## **Ford Scorpio, model year 09.1994-09.1995**

### **With semi-automatic air conditioning**

#### **Blower motor occasionally fails**

# Bulletin

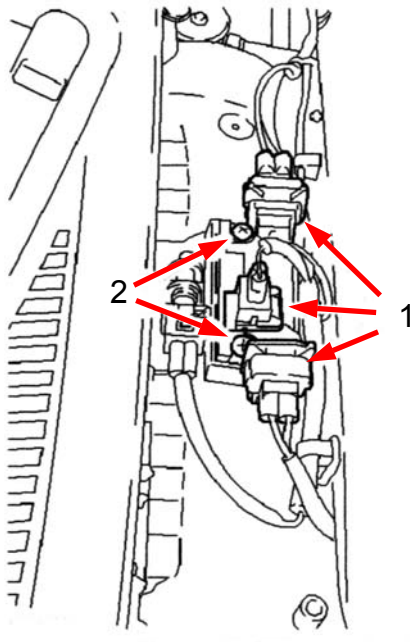
If there are complaints about the above-mentioned fault, the cause could be a faulty blower motor resistor. This occurs due to overheating of the resistor heat sink, and with the air conditioning system switched off.

In this case, a modified resistor must be fitted.

- Remove the connector (1).
- Remove the screws (2).
- Fit a new blower motor resistor.
- Carry out a functional check of the blower motor.
